OFFICE OF THE SELECT BOARD

TOWN OF ARLINGTON
MASSACHUSETTS 02476-4908

**Re: Notice of Proposed Revisions to “Thorndike Place,” Arlington, MA
(MassHousing ID #778/ #779)**

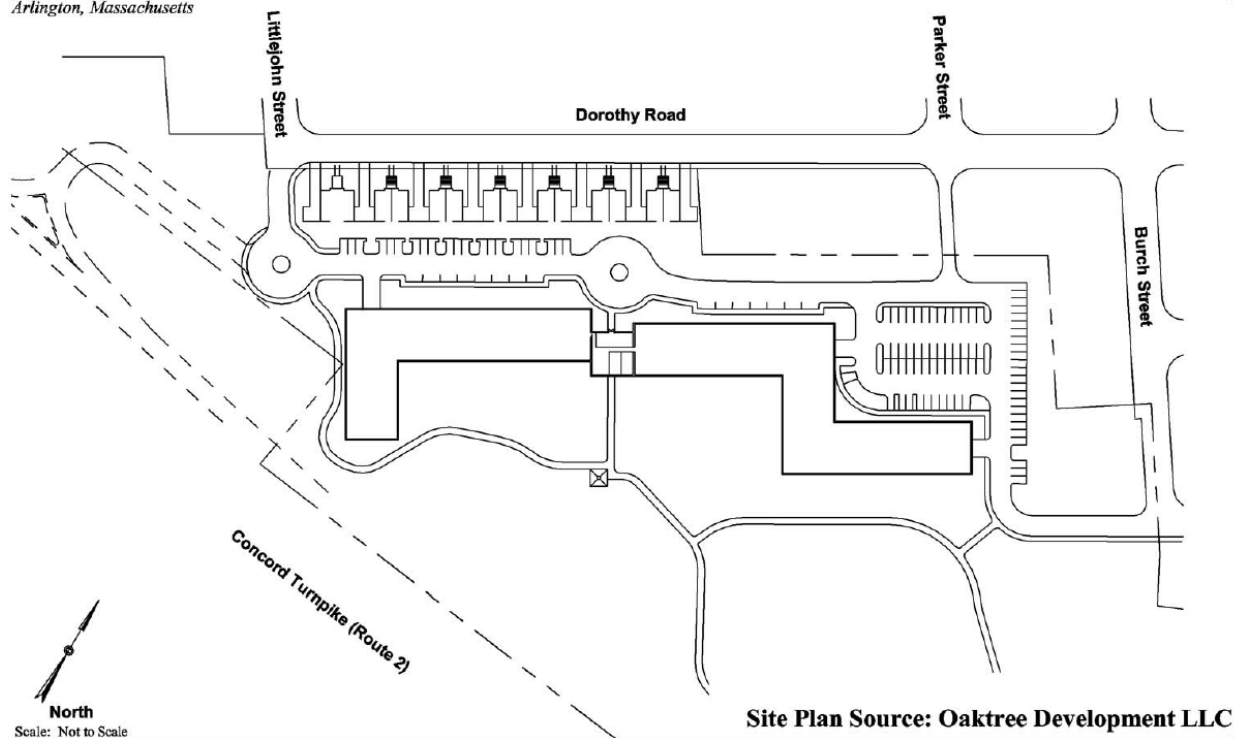
In addition to the foregoing, the project granted preliminary site approval by the revised proposal before you makes no mention of two critical elements to your traffic and transportation assessment and overall evaluation of site appropriateness. First, the site has no access whatsoever to or from Route 2 and no longer features direct access to Parker Street or Burch Street. In its revised form all vehicular access is provided by Little John Street and Dorothy Road, which are essentially the same street for the purposes of this project. Second, the revised project has no walking path improvements to connect the site to a more direct access points to the Alewife T Station or the Minuteman Bikepath. These elements were featured pieces in establishing the appropriateness of a site that still proposes to add parking for more than 200 cars to frequent narrow residential streets. Their abandonment constitutes further substantial and detrimental changes. Four vehicular access points and at least one supplementary pedestrian access point have been reduced to place all vehicular and pedestrian access to a single roadway.

One of MassHousing's principal findings with respect to the general appropriateness of the site for redevelopment was that "[t]he Site is accessible to Route 2, which borders the site." See Eligibility Letter at Attachment "1," Findings "(b), p. 8. Indeed, both the site plans submitted by the Applicant to MassHousing, and the April 2014 Traffic Impact and Access Study by MDM Transportation Consultants highlighted access to Route 2 a feature for MassHousing given the constraints of the modest neighborhood streets otherwise necessary for ingress and egress. As MDM's report stated:

(As can be seen in MDM's "Figure 2," both the Rt. 2 Ramp and Burch Street and Parker Street access were prominent features of the Site Plans submitted for Site Approval to MassHousing)
